**AGENDA
PLANNING COMMISSION
CITY OF WYOMING, MINNESOTA
JUNE 23, 2026
7:00 PM**

TO:	Planning Commission
DATE	6/18/2026
MEETING DATE:	6/23/2026
FROM:	Kim Lindquist, City Planner Fred Weck, Zoning Administrator
RE:	Sunrise Riverbank Commercial Preliminary Plat
APPLICANT:	Sunrise Riverbank Properties
PROPERTY OWNER:	NTD-Com LLC
PROPERTY:	21.10302.33
FILE NO.:	D-26-004

Re: Sunrise Riverbank Commercial –
Development Plan Review
WSB Project No. 033716-000

SITE & UTILITY PLAN

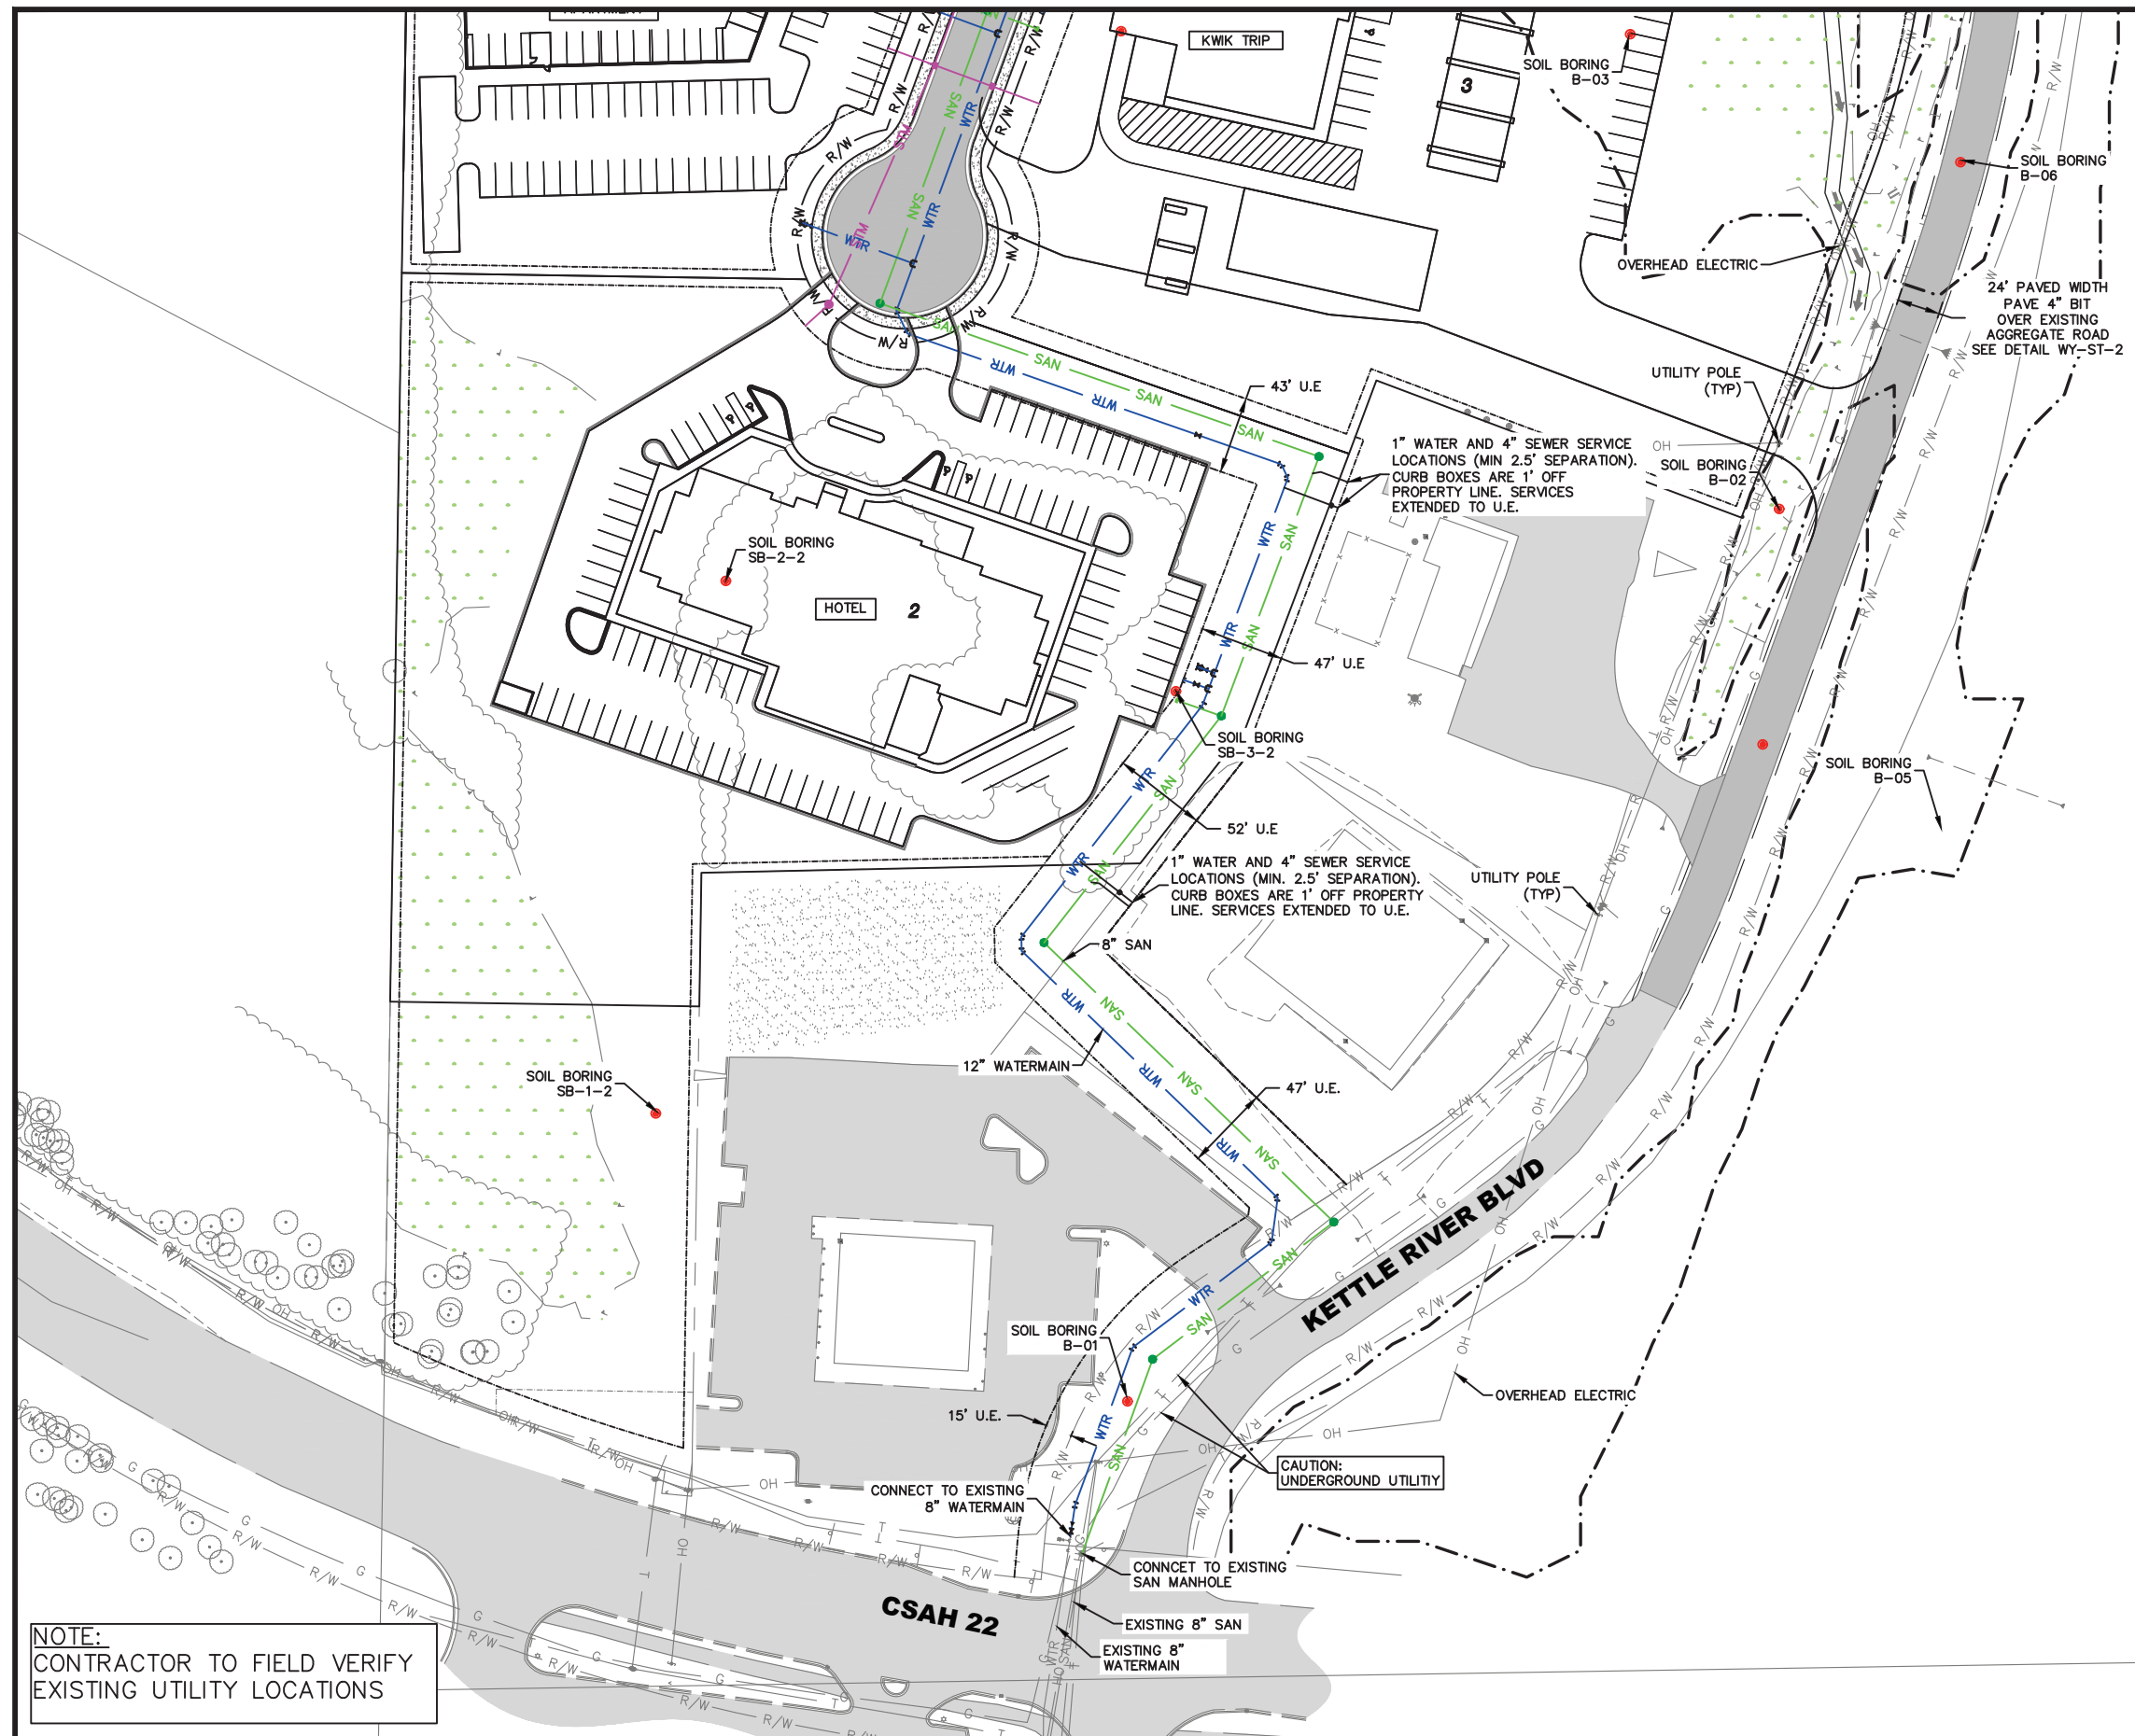
- e. Address redline comments on attached plan set
2. Utilities –
 - a. Sewer service will be extended from the existing sewer line located at the NW quadrant of East Viking Boulevard and Kettle River Boulevard. The City of Wyoming recently upsized the downstream sanitary sewer force main to accommodate the additional flows from this area of the community.

- b. Watermain is proposed to be extended from the recent constructed trunk watermain extended from the north water tower to the northern limits of this development and the existing watermain located at the NW quadrant of East Viking Boulevard and Kettle River Boulevard. Their proposed watermain will complete this watermain loop and provide service to their development and improved overall system reliability.

- c. The development will need to extend water west along Viking Blvd and stub at west parcel boundary limit to provide future connectivity with their residential development and allow adjacent properties access to watermain.

- i. See redlined comments about connections. A concept figure of the conceptual roundabout is shown on plan comments to help determine watermain location.

- ii. Verify ROW location. Easements will be required to obtain for additional watermain alignment.
- d. Verify all crossings maintain the 18" minimum clearance from outside of pipe to outside of pipe.

- g. Show hydrant tees in profile
 - i. Adjust watermain and/or hydrant locations such that hydrants are located at all system high points. (station 79+50, sheet 13)

KETTLE RIVER BLVD

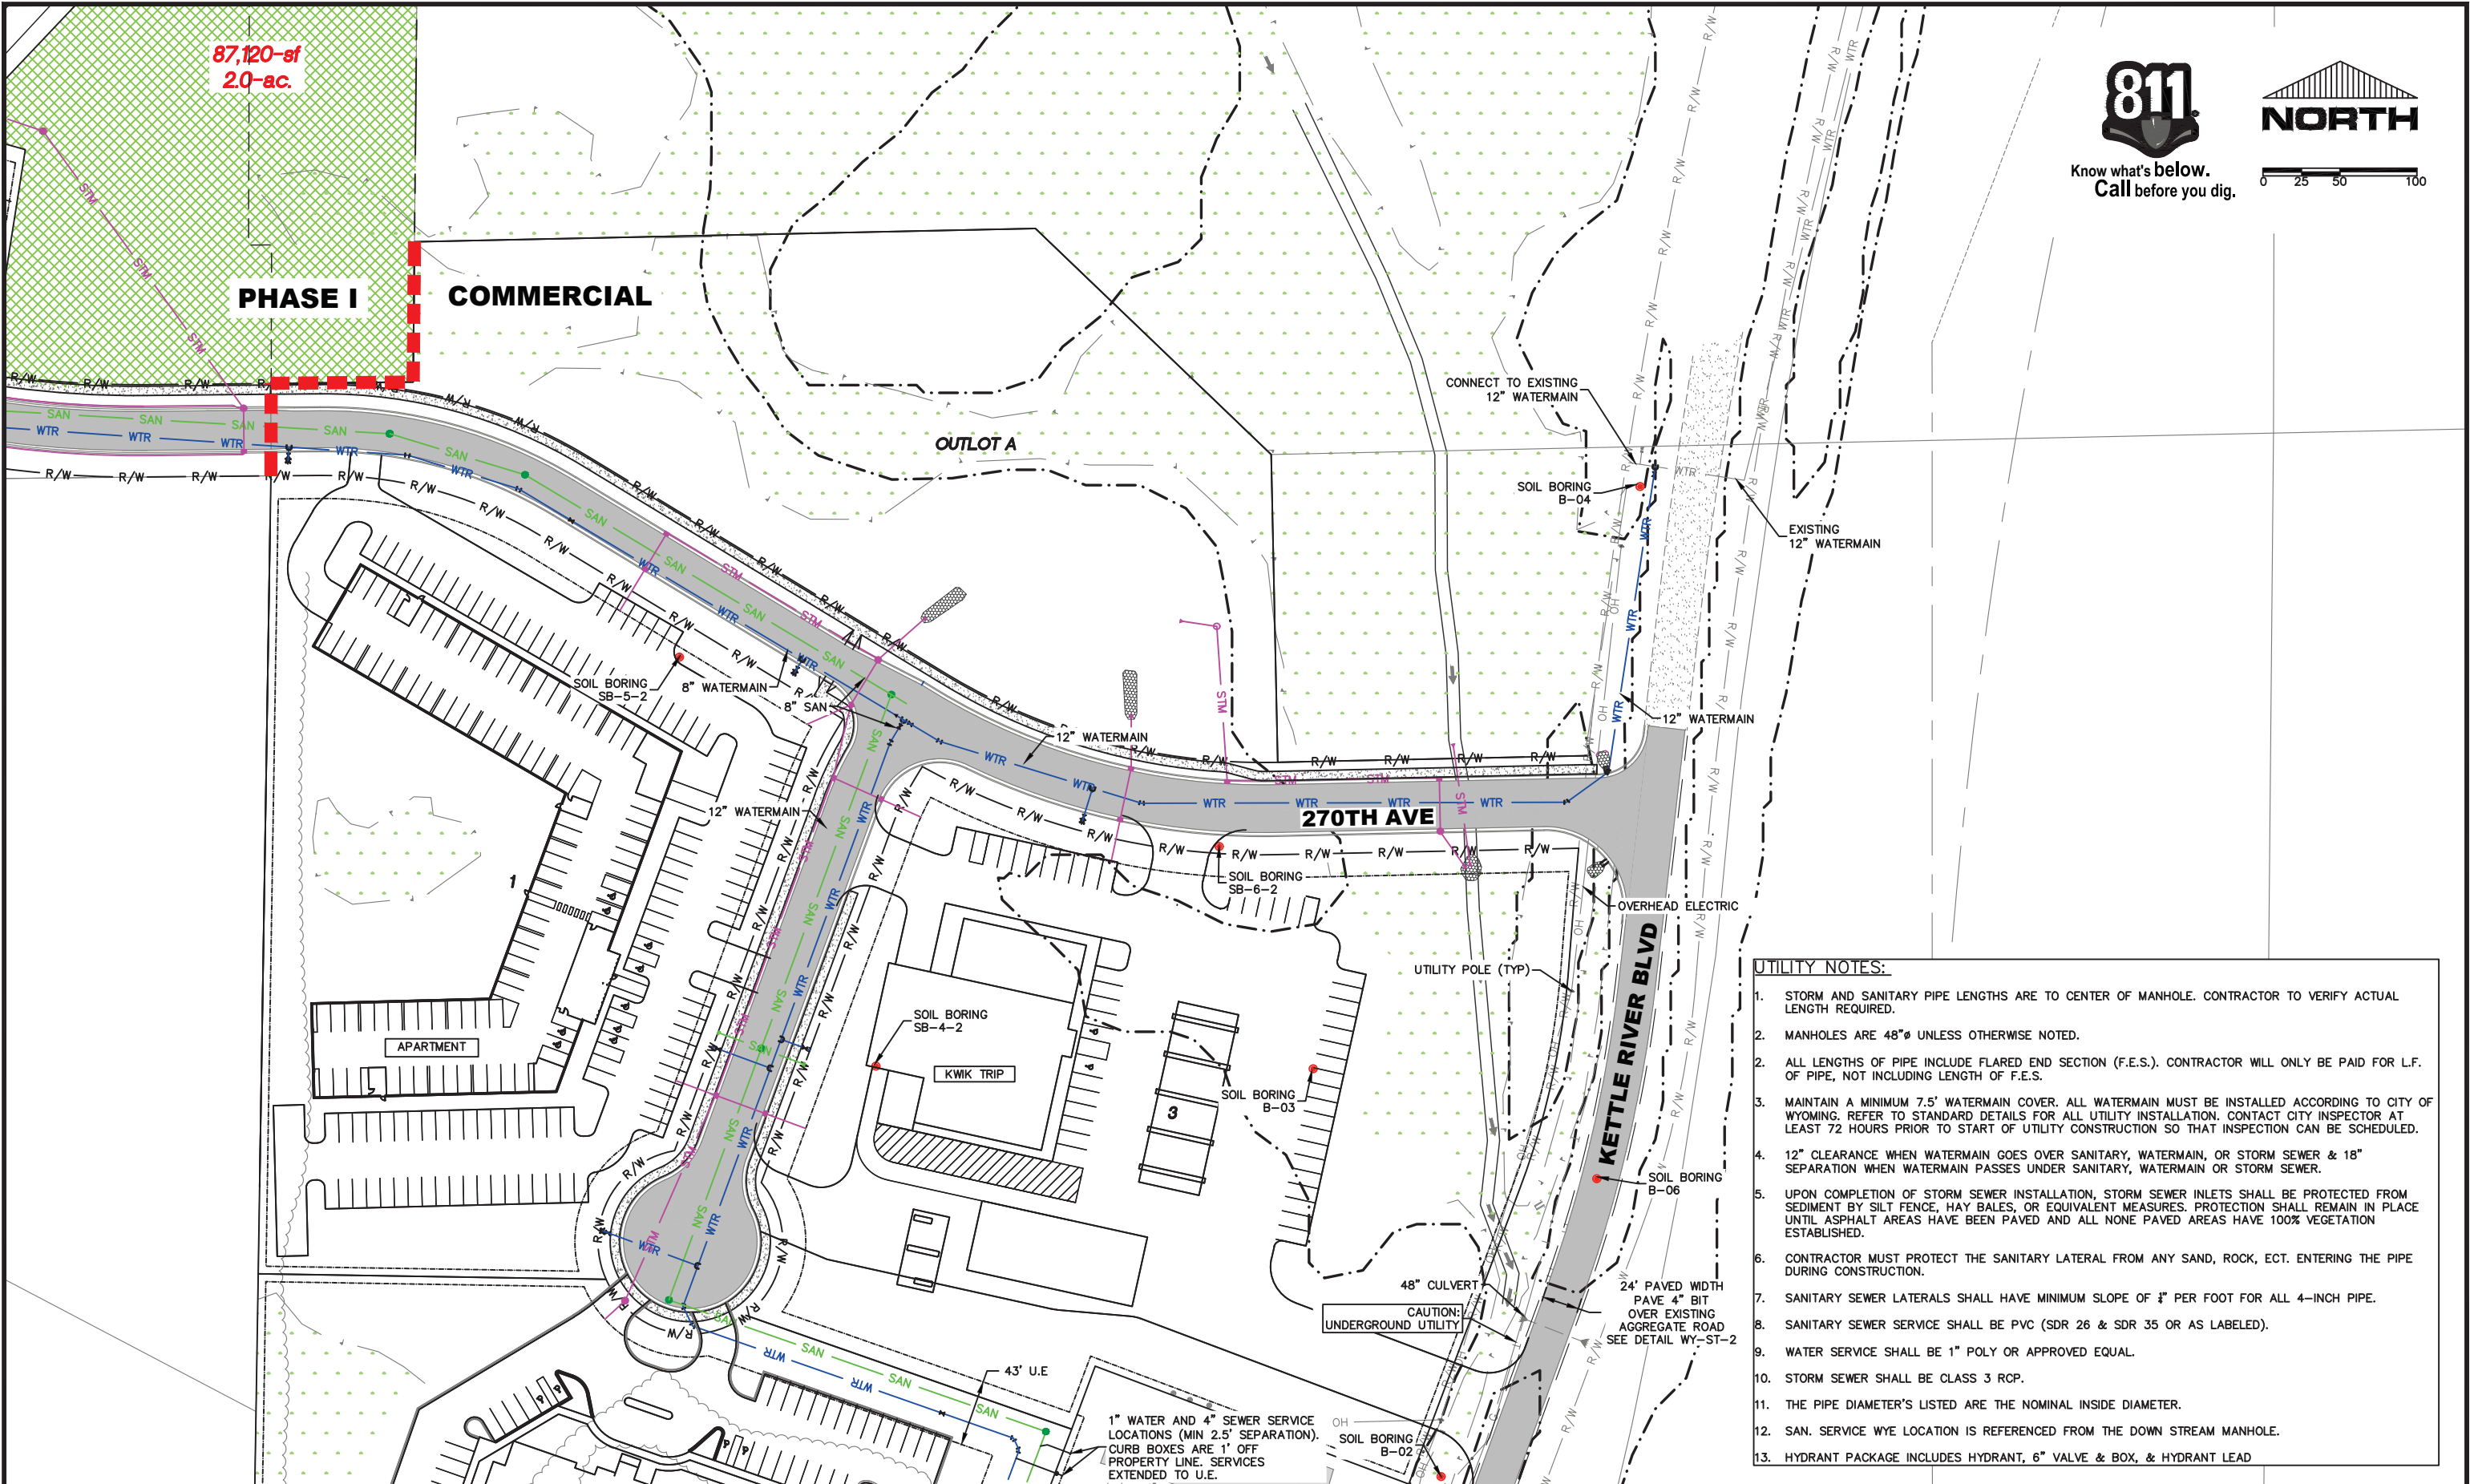
- a. Kettle River Blvd
 - i. Existing gravel road section – Modifications are needed for this section of road as internal proposed roadways are 35 ft face of curb to face of curb while Kettle River Boulevard is proposed at 24 feet wide with no curb and gutter. There are challenges and significant costs associated with making this section of Kettle River Boulevard an urban section and staff is prepared to discuss further details with the applicant on acceptable urban or rural sections for Kettle River Boulevard.

- b. Traffic study suggests the need for a temporary signal at the intersection of CSAH 22 and Kettle River Blvd. Please update plans accordingly.
- c. Adjust RAD2 and RAD3 on Sunrise Ct Cul-de-sac to 44' to meet city standard plate detail WY-ST-9.
